TECHNICAL EVALUATION REPORT

TECHNICAL EVALUATION REPORT FOR THE EVALUATION
OF ODCM REVISION 7 JOSEPH M. FARLEY NUCLEAR
PLANT, UNITS 1 AND 2

NRC Docket No. 50-348 NRC LICENSE NO. NPF-2
NRC Docket No. 50-364 NRC LICENSE NO. NPF-8

Figure 1. Radioactive liquid waste treatment system and effluent monitors.
 (Reproduced from Figure 2-1 of the ODCM, Revision 7 for the Joseph
 M. Farley Nuclear Plant.)

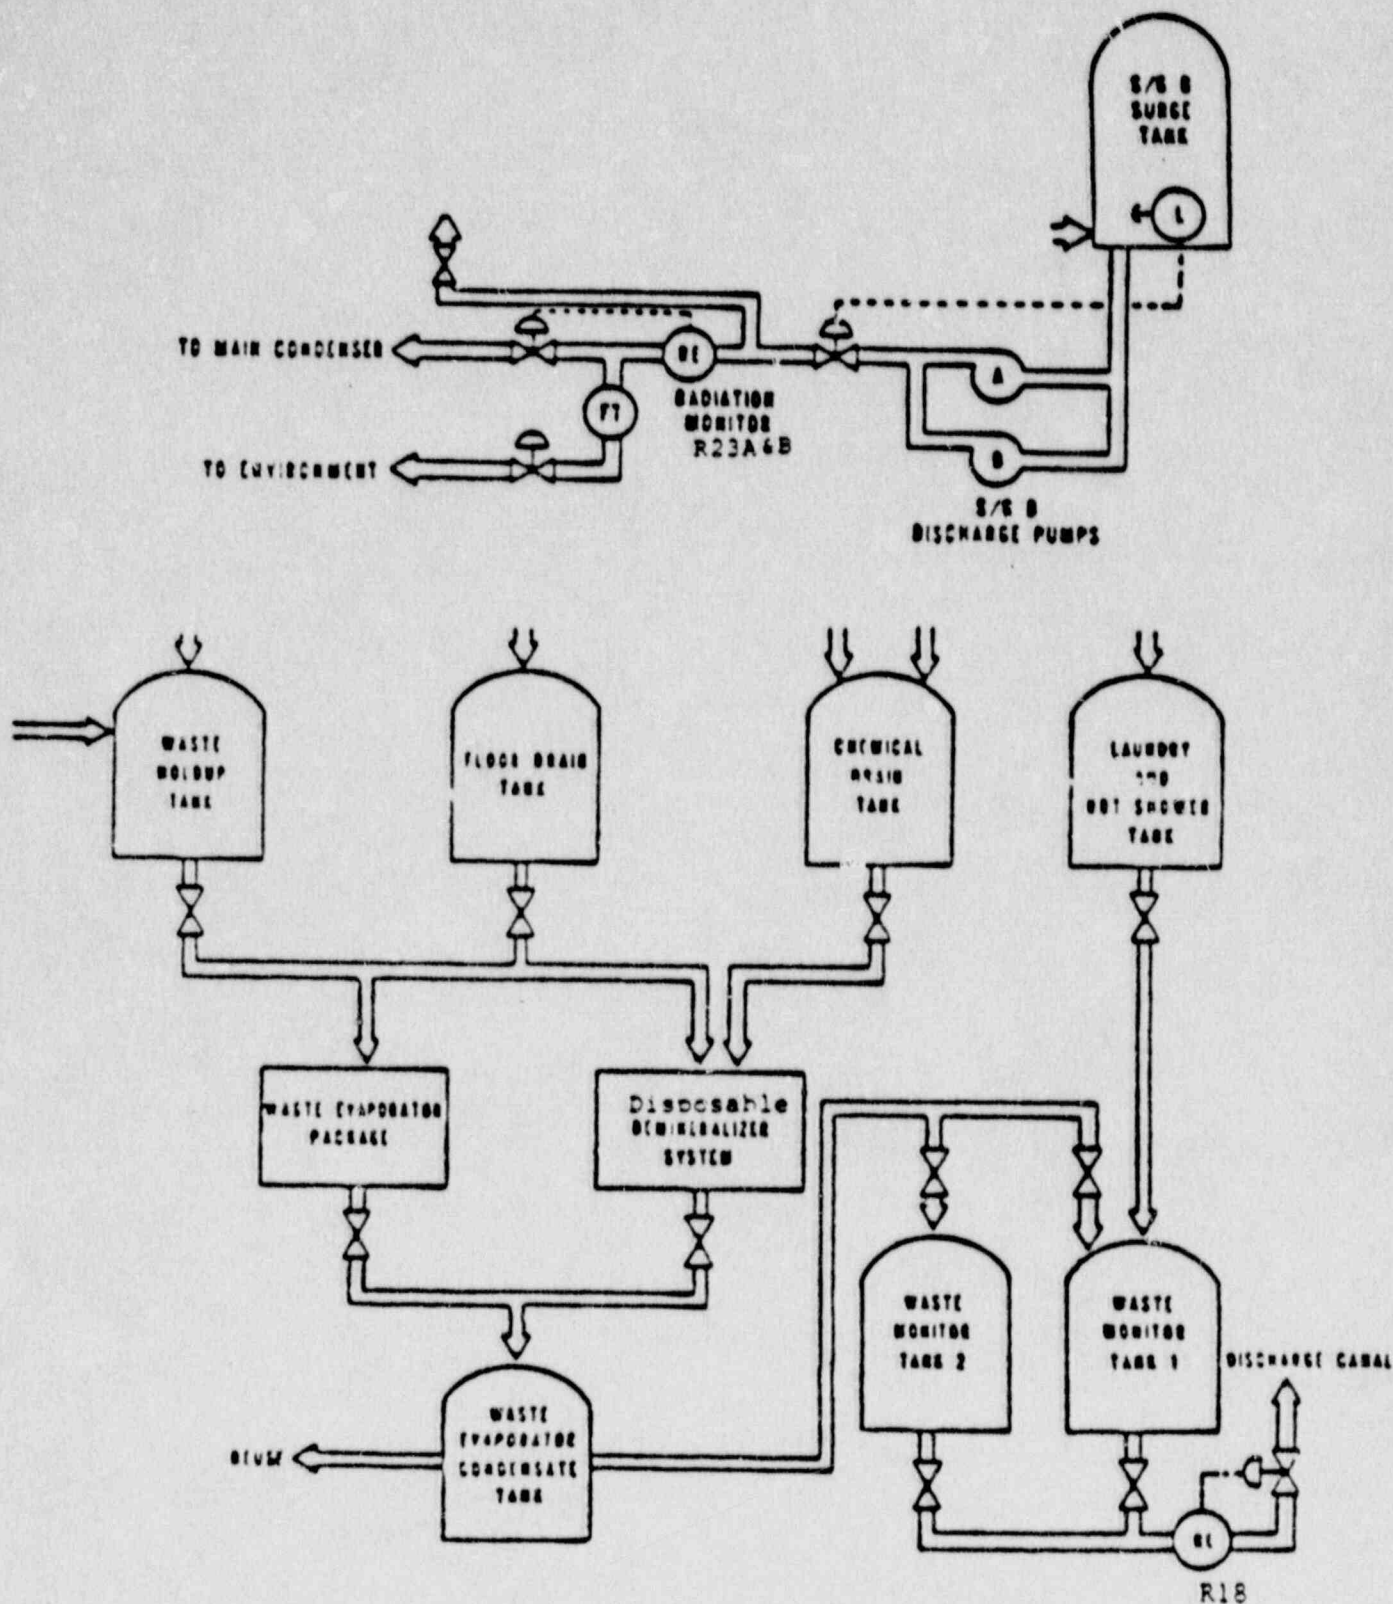
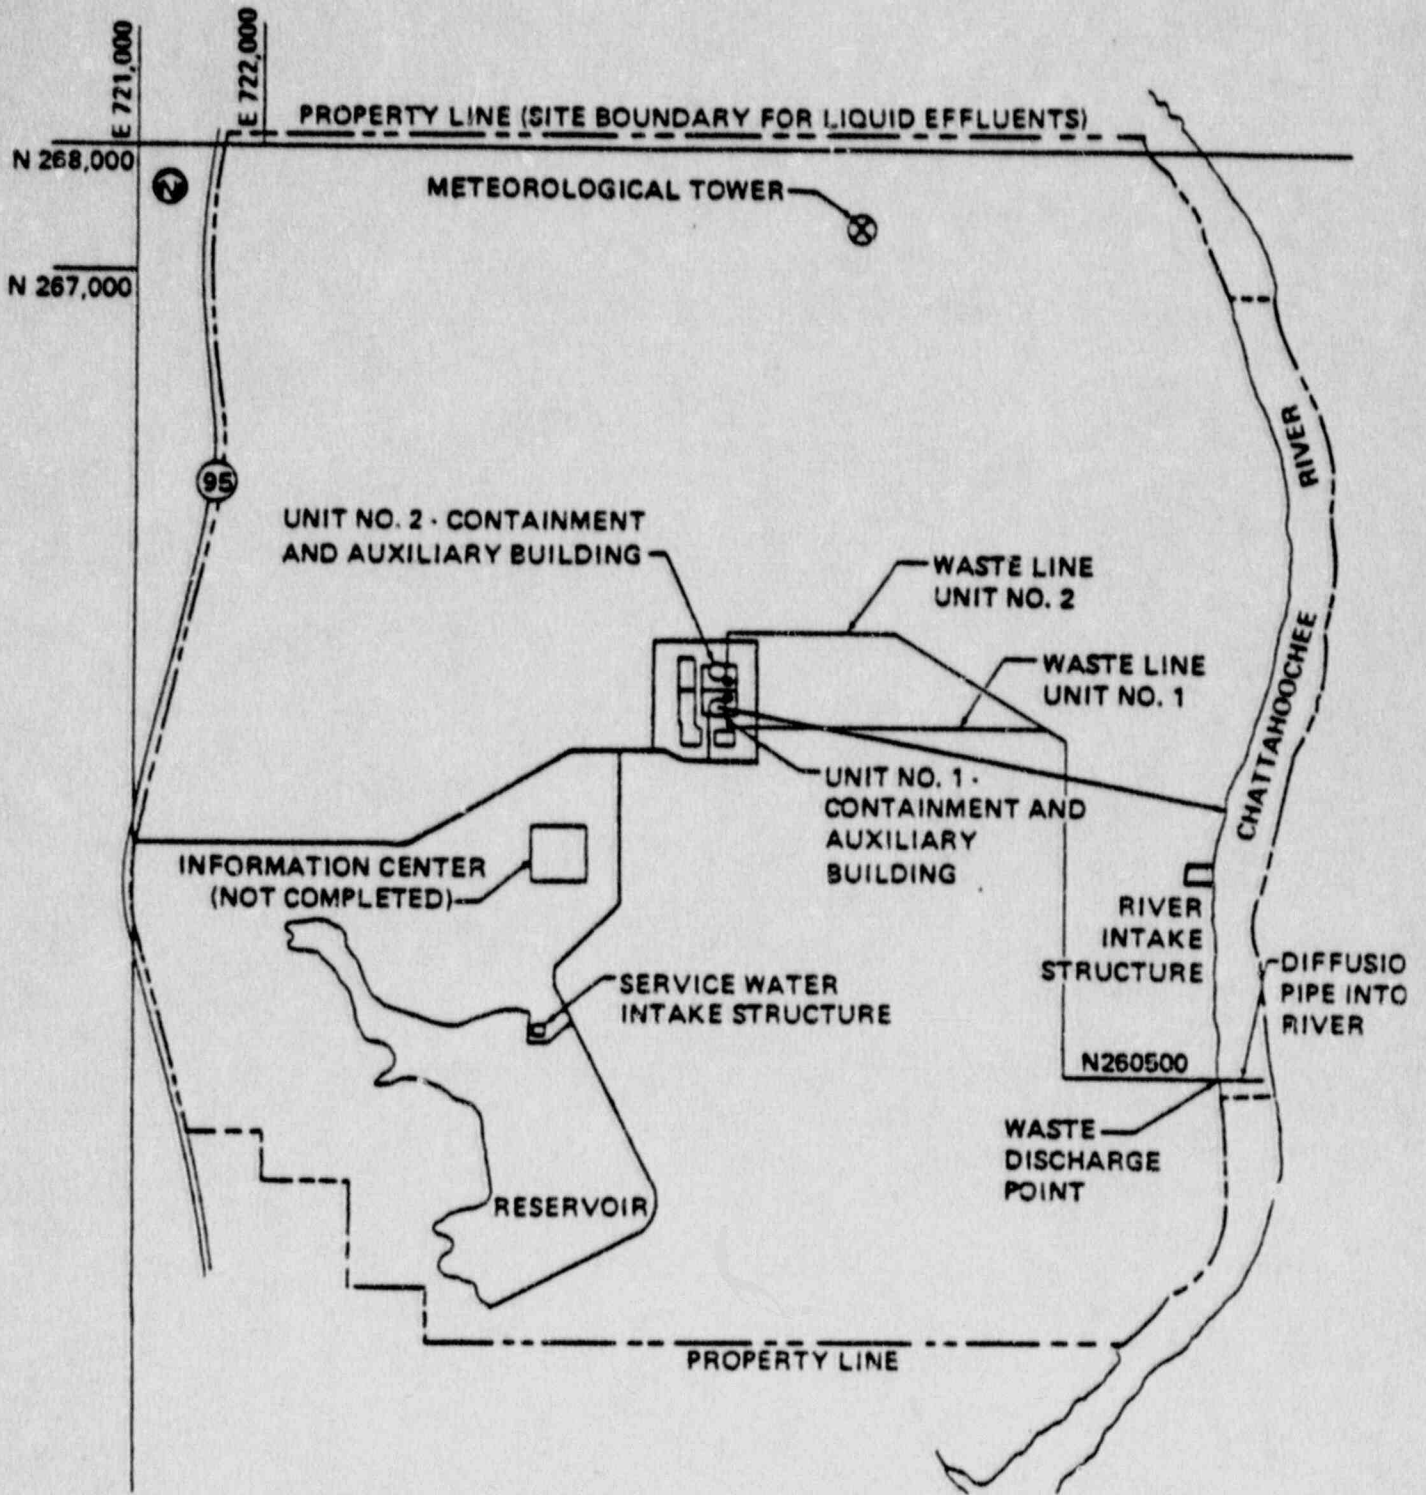
details are not clear from Figures 1 and 2 and the discussions in the ODCM: (a) whether the systems shown are common to both reactor units or exist separately for each unit; (b) whether the Waste Lines shown in Figure 2 are the same as the Liquid Radwaste Effluent Lines identified in Table 3.3-13 of the Technical Specifications; and (c) whether the dilution flow rates discussed are defined for the two units separately or for the site as a whole. The ODCM should clarify these points with a figure and/or a detailed verbal description of the pathways of radioactive liquid waste and dilution water from each source to the discharge point in the Chattahoochee River.

The discussions of setpoints, dose rates, and doses, respectively, in Sections 3.2, 3.5, and 3.7 below are based on assumptions that the systems shown in Figure 1 exist separately for each reactor unit and that the "dilution water flow rate," F_D , refers to the flow rate of dilution water from the site at the Waste Discharge Point shown in Figure 2.

Figure 2-1 in the ODCM is a diagram of the liquid radwaste treatment system at FNP, and Figure 3-1 is a diagram of the gaseous release sources and release points. Figure 2-1 should be clarified or another figure added to indicate the pathways from sources to the release point, as discussed in Section 3.1 above. No diagram of the solid waste management system is included in the ODCM.

- In Section 2.1, another figure and/or a detailed description should be added to clearly define the pathways of radioactive liquid waste and dilution water from each source to the the discharge point in the Chattahoochee River.

Figure 3. Gaseous radwaste treatment system and effluent pathways.
 (Reproduced from Figure 3-1 of ODCM, Revision 7 for the Joseph M. Farley Nuclear Plant.)

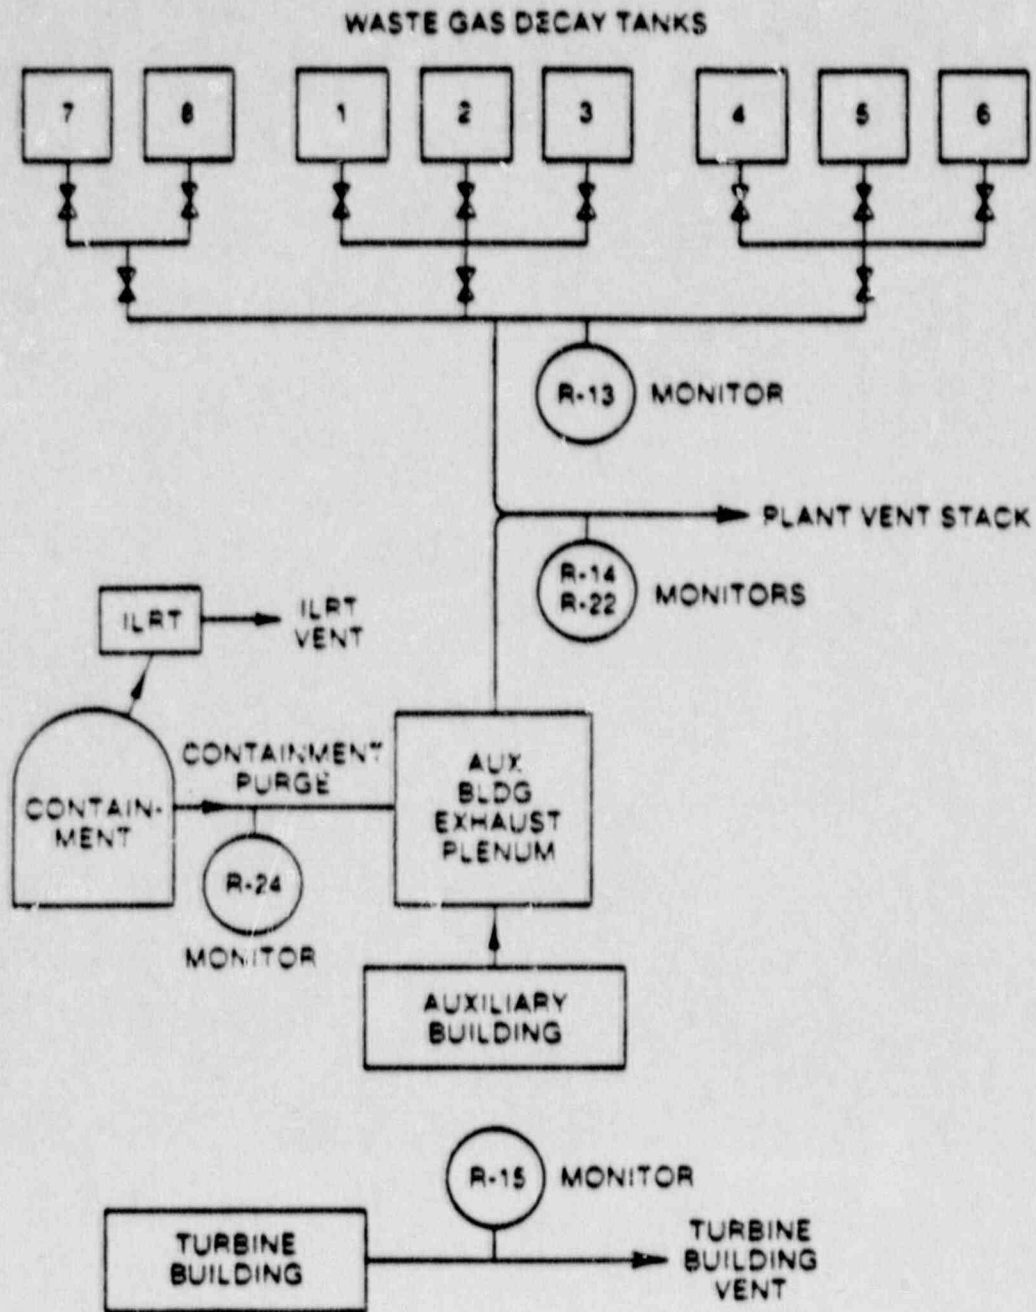
Technical Specification 3.3.3.11 requires noble gas activity monitors at the Steam Jet Air Ejector (R-15, shown between the Turbine Building and the Turbine Building Vent in Figure 3), the Vent Header System (R-14 or R-22, shown on the line to the Plant Vent Stack in Figure 3), and the Gaseous Radwaste Treatment System (R-14, also shown on line to the Plant Vent Stack in Figure 3). Monitor R-14 provides automatic termination of release. Figure 3 shows two monitors not required by the technical specifications, one on the line from the Waste Gas Decay Tanks to the Plant Vent Stack (R-13) and one on the line leading from containment to the Auxiliary Building Plenum (R-24). (In ODCM Figure 3-1, monitor R-13 should apparently be shown on the effluent line from all the Waste Gas Decay Tanks instead of from only 3 of 8 as is shown now.)

- A subscript should be added to F in the definition of Δt_s in Section 2.4
- The 3 in Equation 3.6 of Section 3.2 should be $(3)^{1/2}$.
- A definition of M_i should be included in Section 3.6.1.
- In ODCM Figure 3-1, monitor R-13 should apparently be shown on the effluent line from all the Waste Gas Decay Tanks.
- The word "radionuclides" in the first sentence of Section 3.4(b) should read "radioiodines." This sentence should also be reworded so doses due to tritium are required to be calculated.
- The definition of $R_{ip\tau a}$ in Section 3.6.2 should reference Table 3-5 instead of "an appendix."
- The units of distance should be specified in Table 5-1.
